To: Mercedes-Benz Dealer Principals, General Managers, Sales Managers, Service Managers, Parts Managers	From: Anthony Washington, Senior Manager, Regulations and Certifications
<b>Re: Launch Recall Campaign Notification</b> <b>Model: Sprinter</b> <b>Model Years: 2025</b> <b>Replace DISTRONIC Radar Sensor</b>	Date: November 2025

<b>Campaign No.:</b>	<b>Campaign Desc.:</b>	<b>NHTSA ID:</b>	<b>Replace DISTRONIC Radar Sensor</b>
<b>2025110001</b>	<b>VS3RADARS</b>	<b>25V712</b>	
<p>This is to notify you of a <b>Recall Campaign</b> to replace the DISTRONIC radar sensor on approximately <b>16</b> MY 2025 Sprinter Vans. The recall campaign will be visible on the <a href="http://www.NHTSA.gov">www.NHTSA.gov</a> website and may generate questions from customers. All affected VINs will be flagged as "<b>OPEN</b>" in VMI and cannot be sold until remedied.</p>			
<b>Background</b>			
<b>Issue</b>	<p>Mercedes-Benz AG, the manufacturer of Mercedes-Benz vehicles, has determined that on certain Model Year ("MY") Sprinter (907 platform) vehicles, the front short-range radar sensor printed circuit board might not meet specifications. As a consequence, object detection might not be sufficiently robus

**Shown on model 907.6 with code BA3 (Active Brake Assist)**

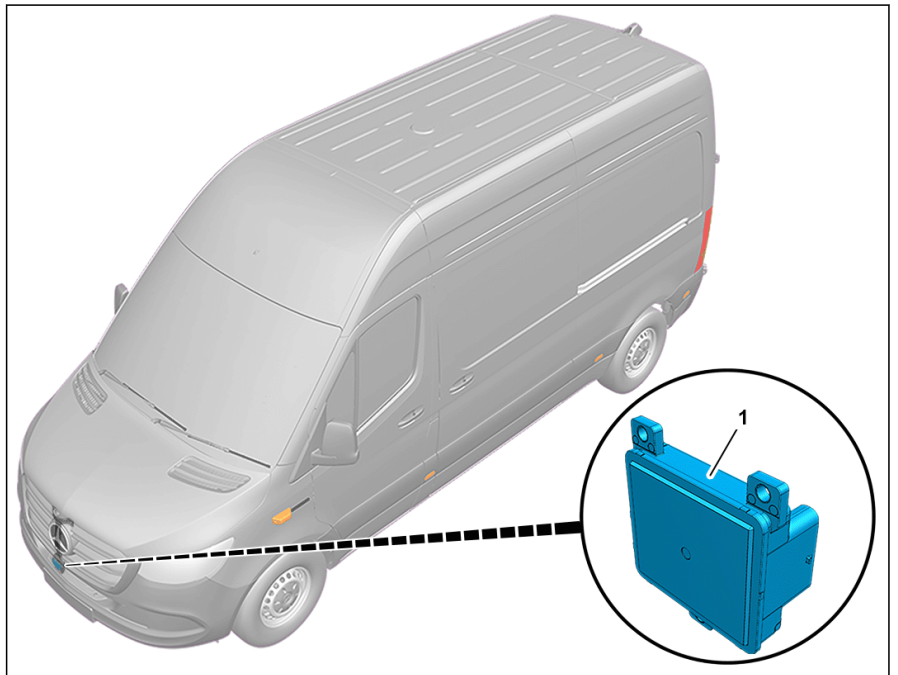
<b>Notice</b>	Notes on carrying out repair work in the vehicle interior		AH68.00-D-0001-01KOS
	<b>Check</b>		
1	Check if vehicle is affected by measure.		
	<b>Replace</b>		
2	Replace front radar sensor.		AR30.30-D-1210TS

5	Commission radar sensor (1) with diagnostic system.		
6 AD	Disconnect diagnostic system.		AD00.00-D-2000-06TS
7 AR	Remove charger from vehicle.		AR54.10-D-1127TS
